IREDELL COUNTY HEALTH DEPARTMENT

IMPROVEMENT PERMIT / AUTHORIZATION TO CONSTRUCT / OPERATION PERMIT / EXISTING SYSTEM INSPECTION

PERMIT# 126497 PIN# 4626326312 DATE 9-15-05

SUBDIVISION Water+Tee Landing BLOCK / SECTION ____ LOT 27 LOT AREA .77 SITE CLASS PS DESIGN FLOW 480 L.T.A.R. .25

AS BUILT SKETCH

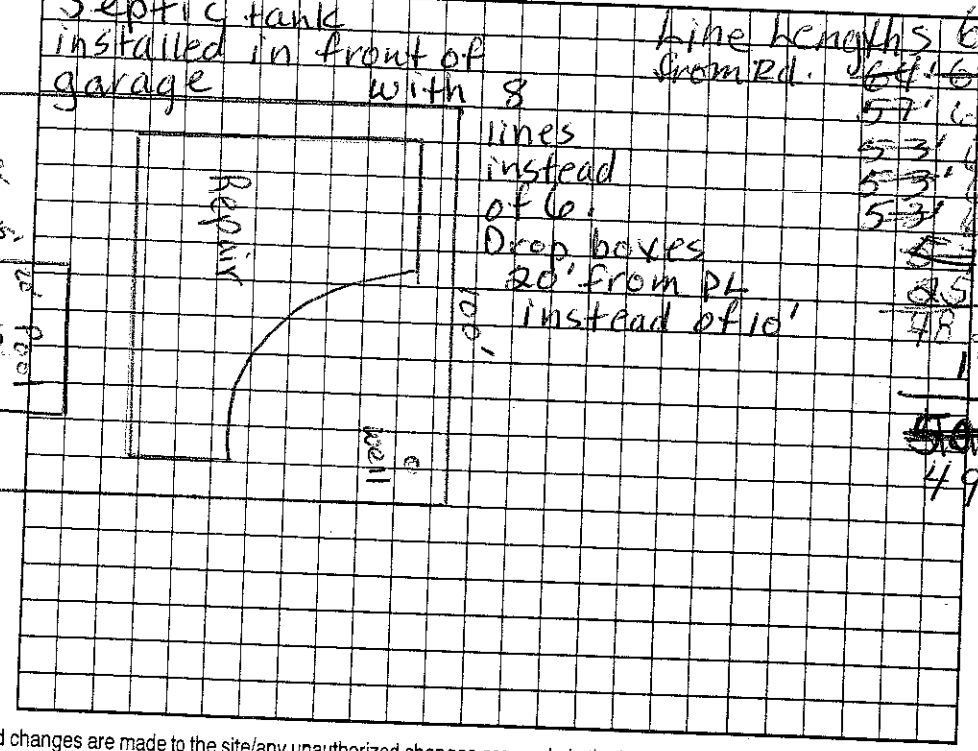
Installed standard infiltrator chamber 500' - 8 lines - lengths listed below Yellow tuf tite filter. Septic tank w/marker Installed as follows: Septic tank installed in front of garage with 8 lines instead of 6. Drop boxes 20' from PL instead of 10'

Line lengths from Rd.: 69', 64', 67', 60', 57', 63', 53', 68', 53', 69', 53', 62', 157', 85', 118', 48', 2', 18', ~~570'~~ 490'
